EAGLE RANCH ROAD, N.W.

CHANGE ORDER NO. 7

SHEETS 1,4,5,6,7,8,9,10,11

The above-mentioned sheets are temporary additions to the final plans for Eagle Ranch Road. They outline the paving plan for completing approximately one half of the road as directed by the owner. Upon completion of the entire road section, these sheets shall be replaced by the originals.

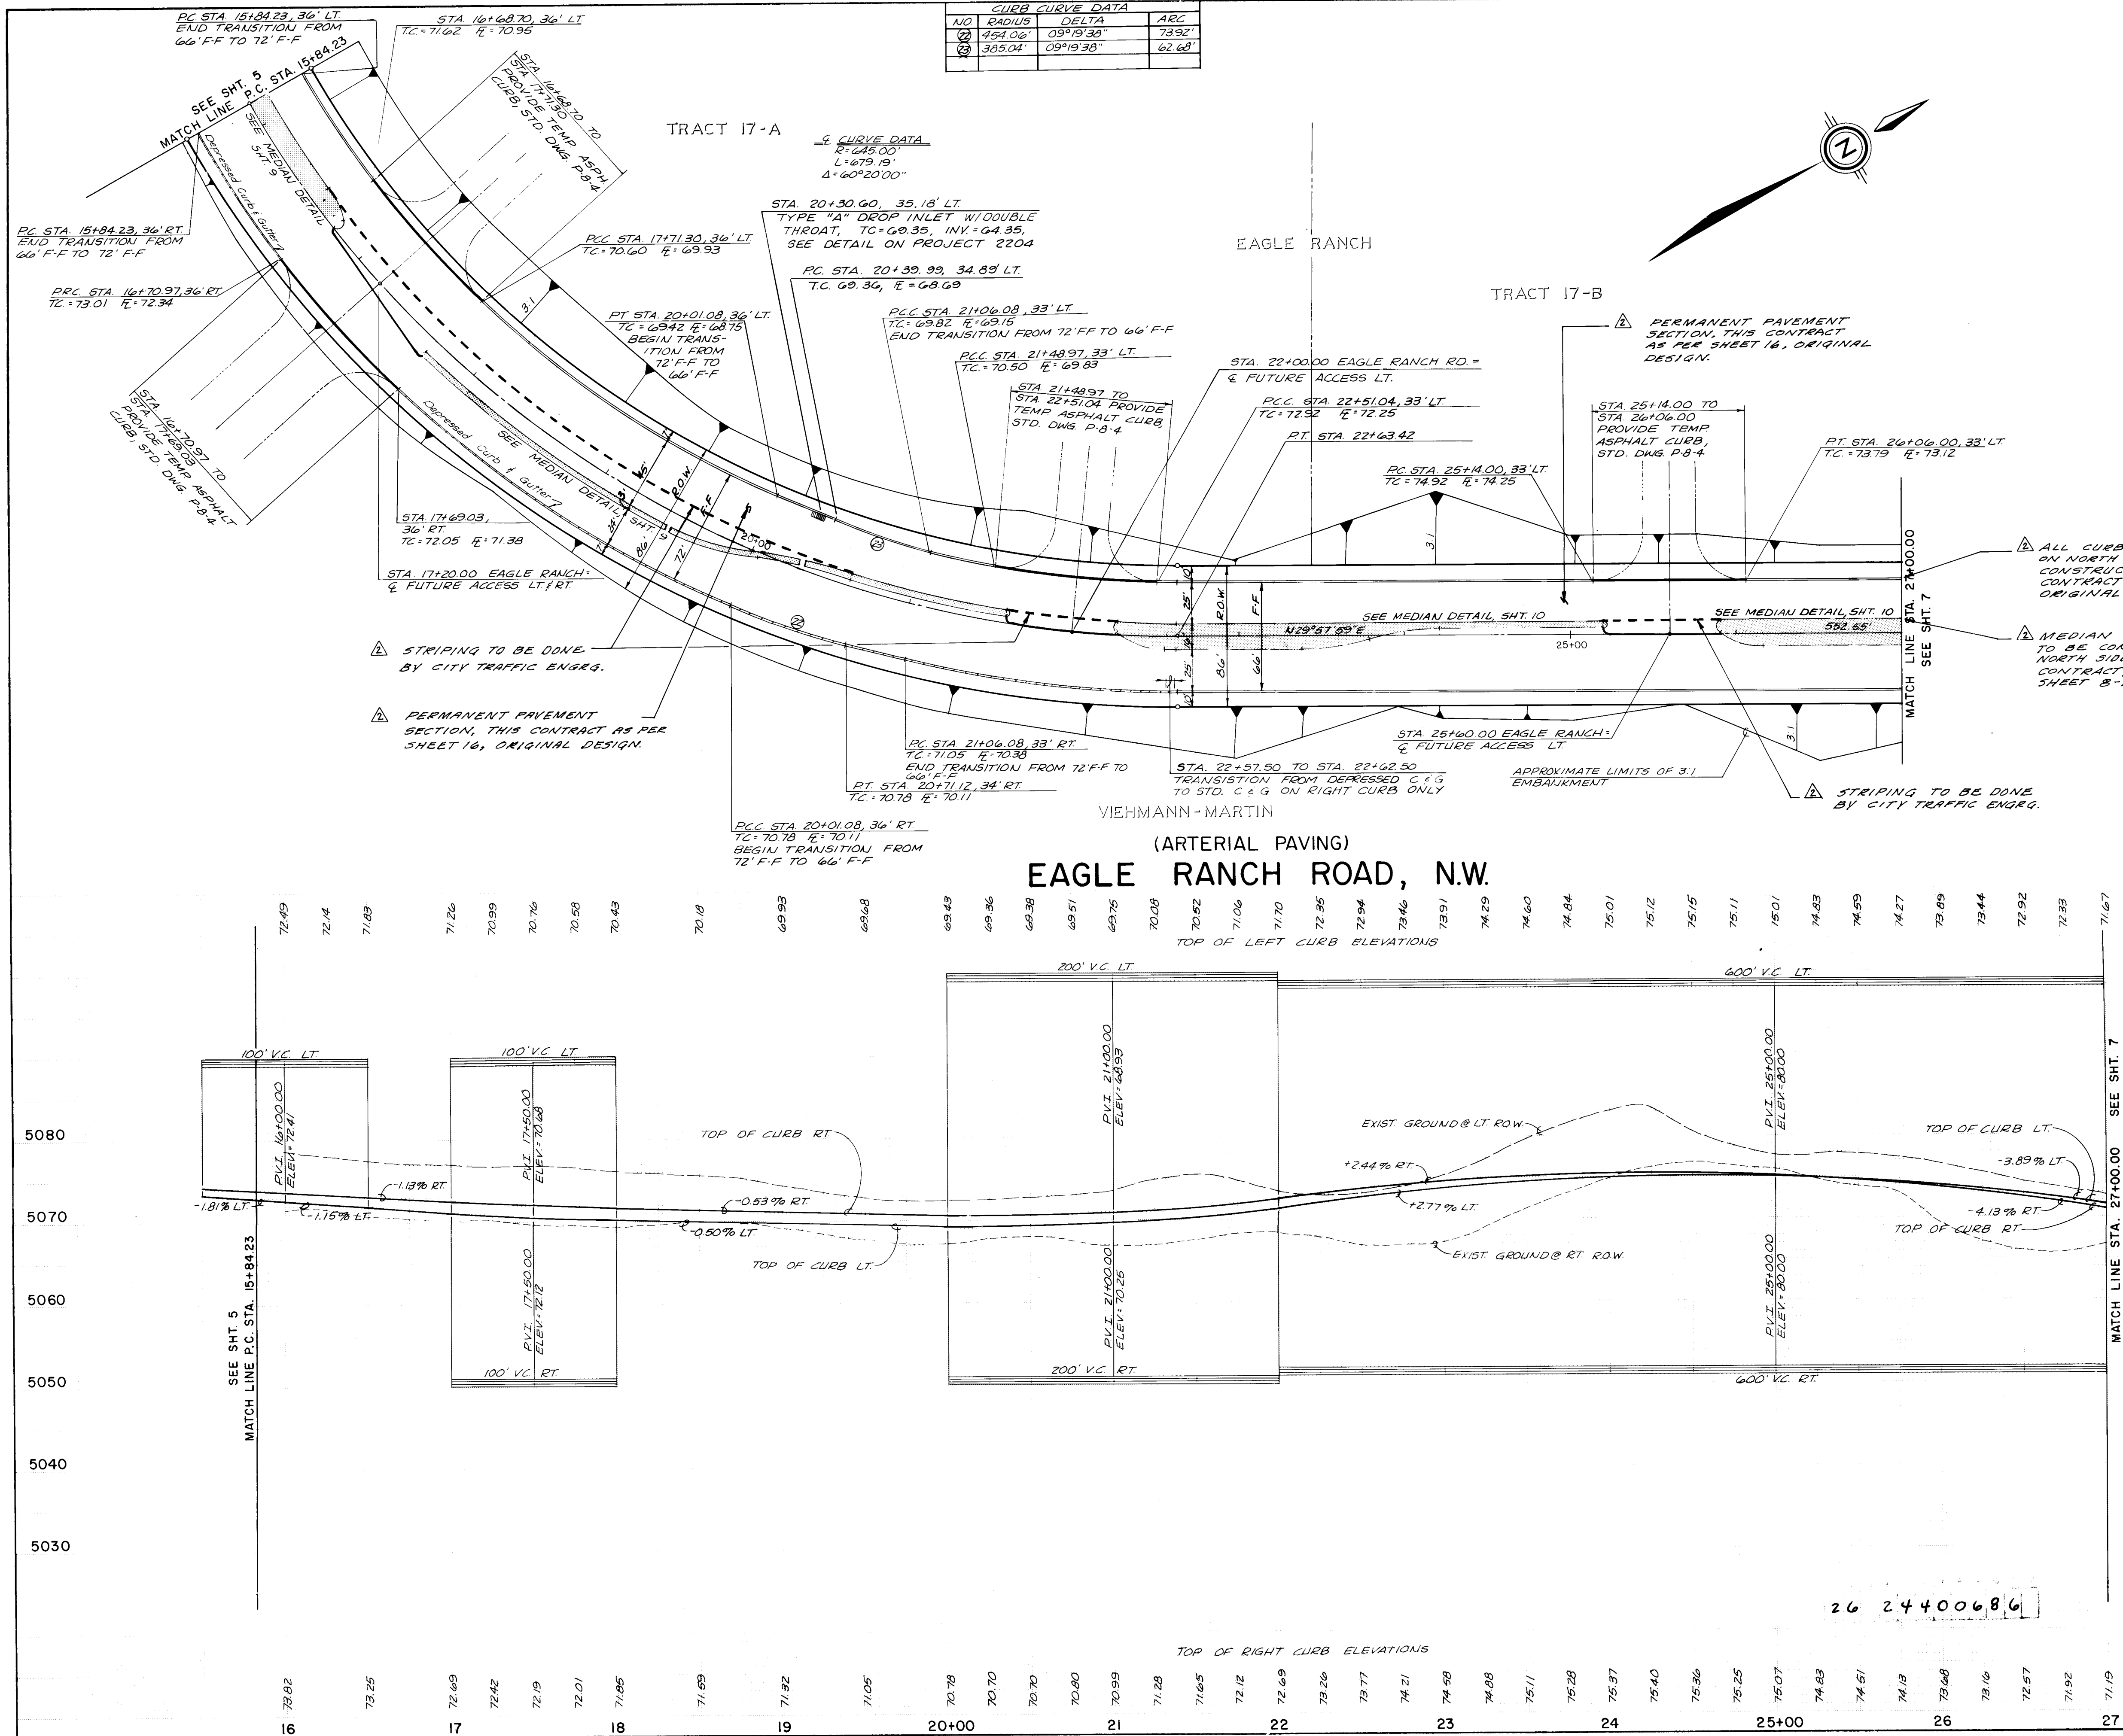
The above-mentioned sheets are temporary additions to the final plans for Eagle Ranch Road. They outline the paving plan for completing approximately one half of the road as directed by the owner. Upon completion of the entire road section, these sheets shall be replaced by the originals.

Note that no alterations were made to any permanent horizontal or vertical alignments. The only changes on these sheets involve temporary elimination of road section, curb and gutter and temporary construction of asphalt pavement and curb, which were drawn by Easterling & Associates, Inc., February, 1986.

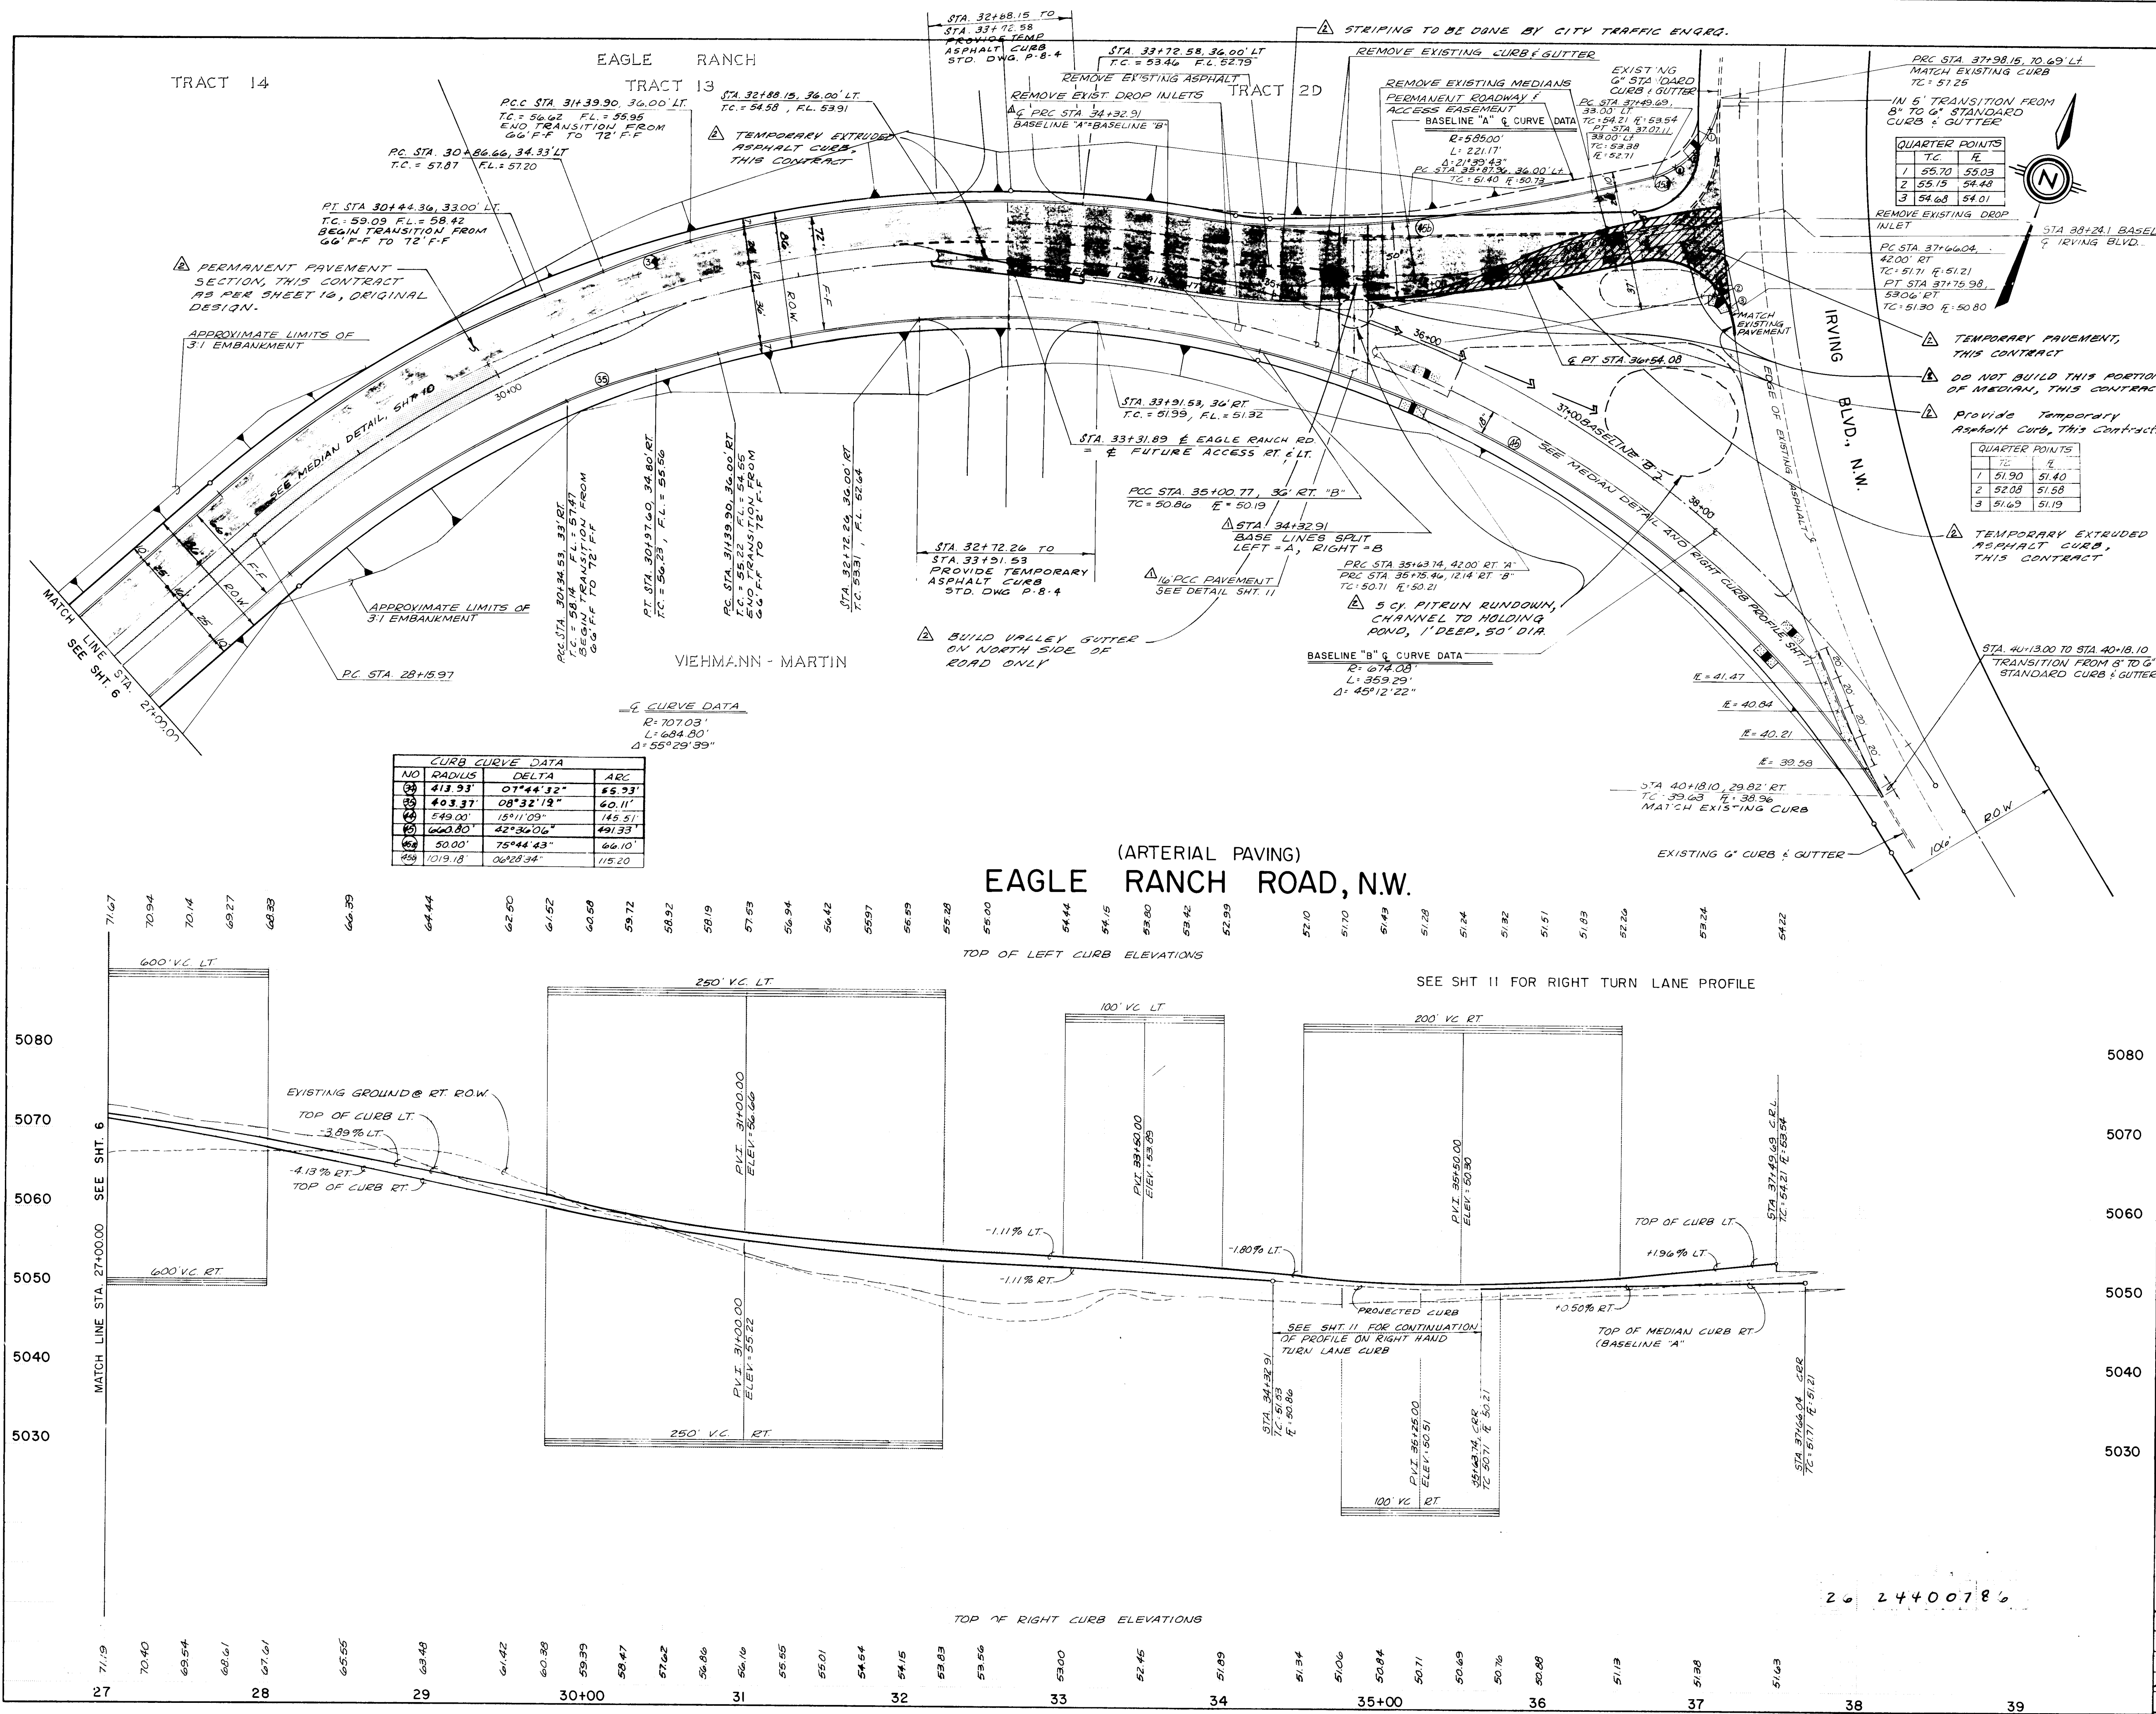
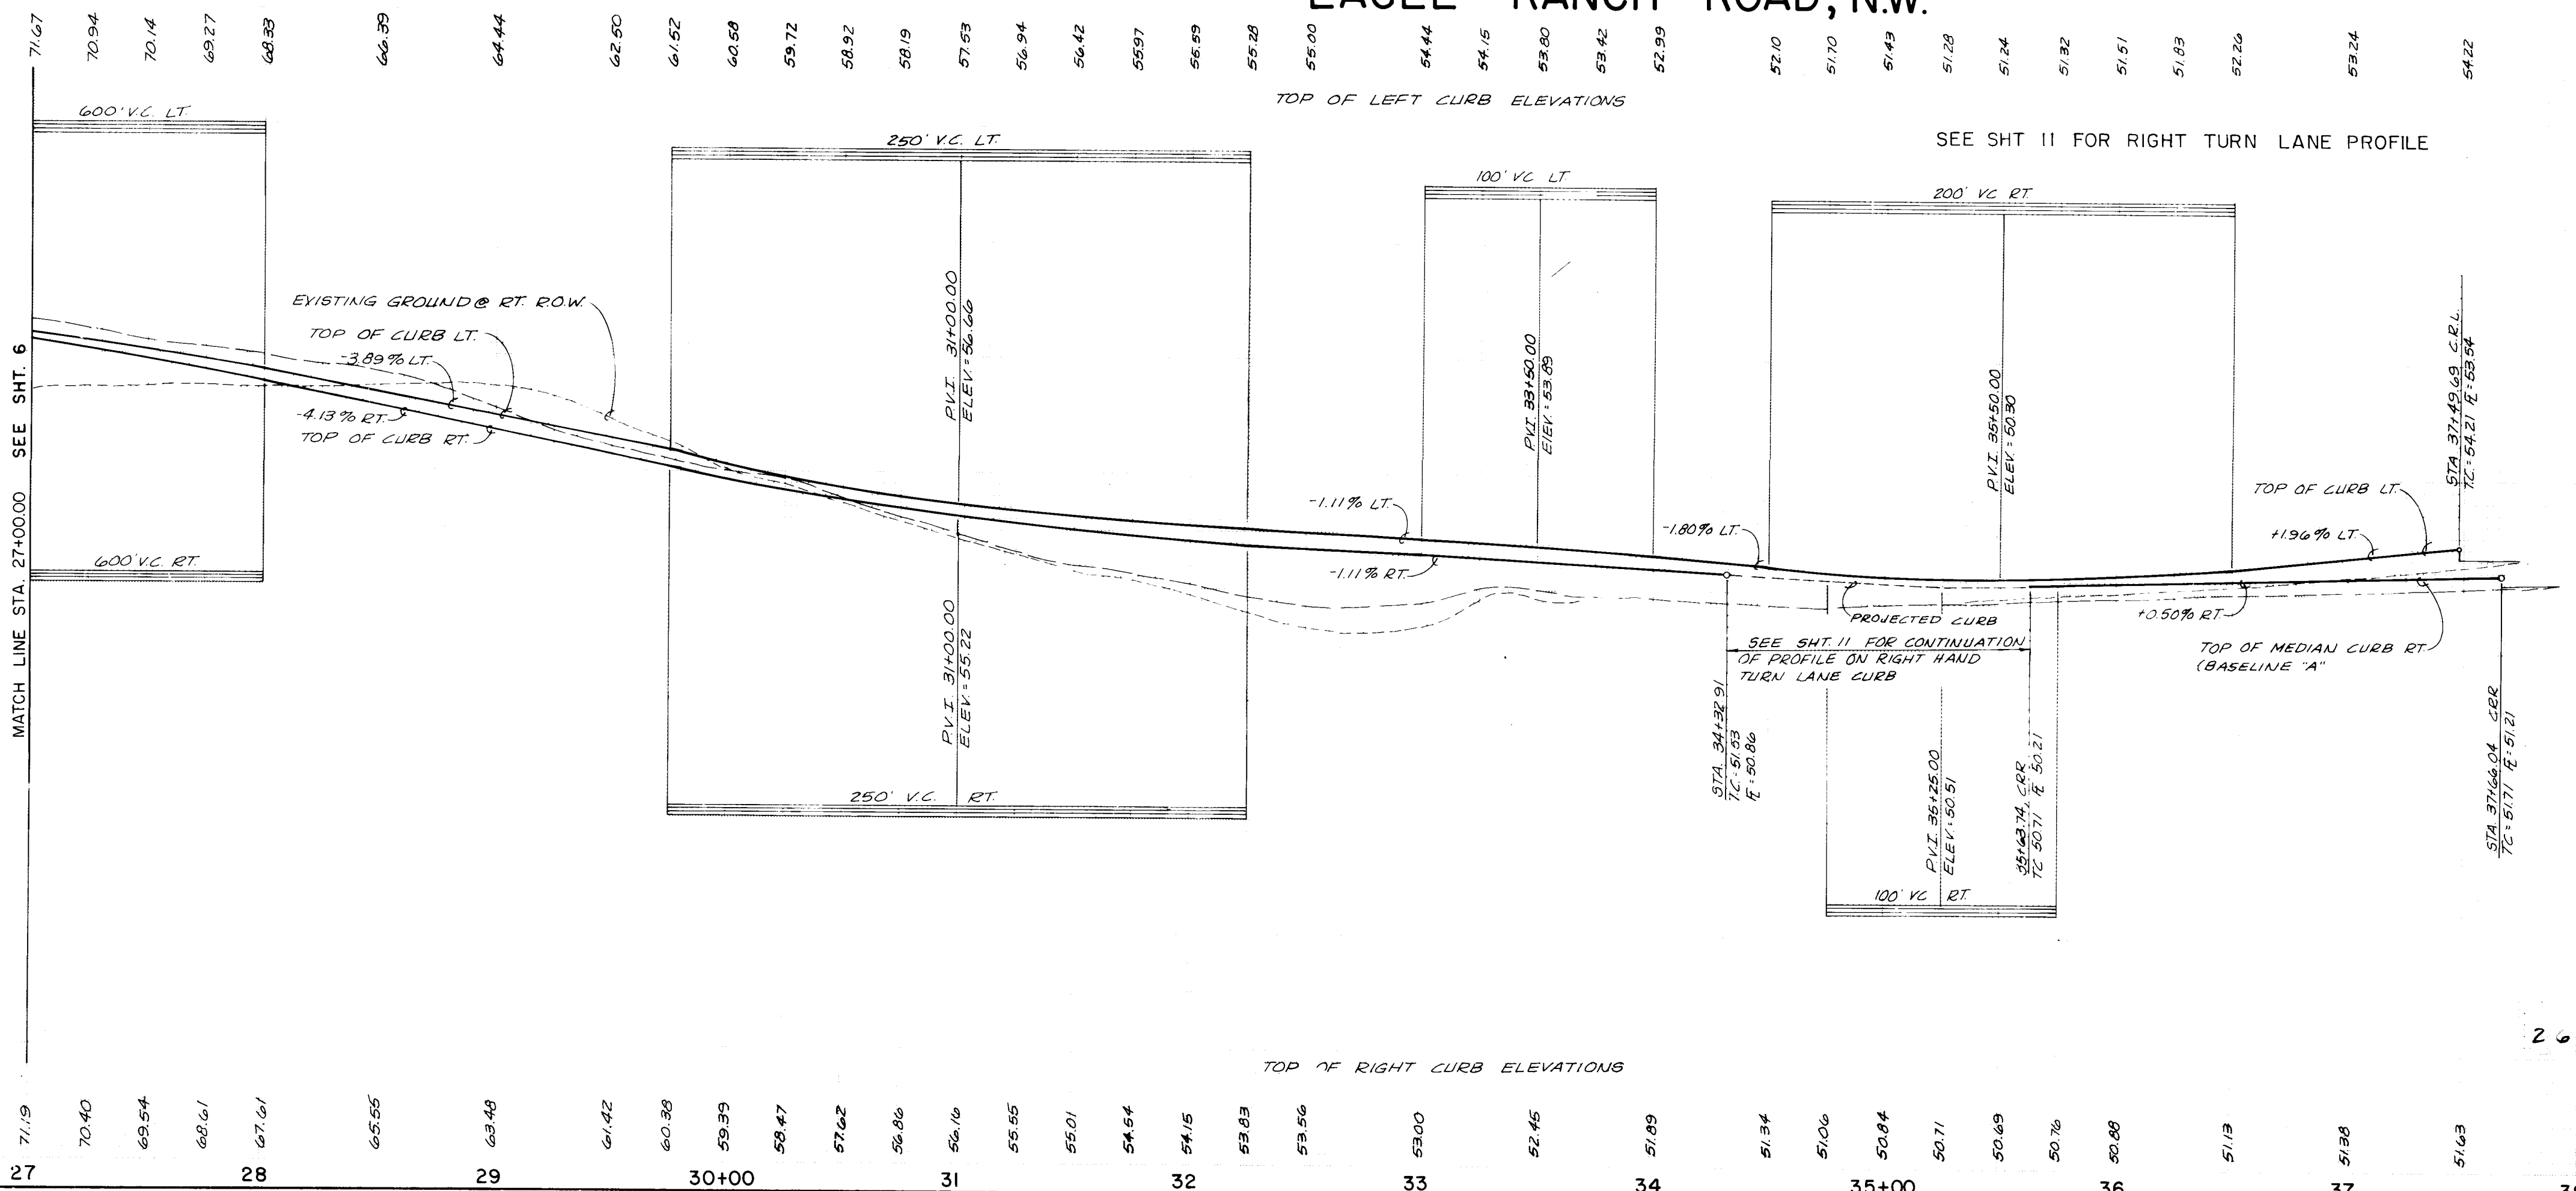
The above-mentioned sheets are temporary additions to the final plans for Eagle Ranch Road. They outline the paving plan for completing approximately one half of the road as directed by the owner. Upon completion of the entire road section, these sheets shall be replaced by the originals.

Note that no alterations were made to any permanent horizontal or vertical alignments. The only changes on these sheets involve temporary elimination of road section, curb and gutter and temporary construction of asphalt pavement and curb, which were drawn by Easterling & Associates, Inc., February, 1986.
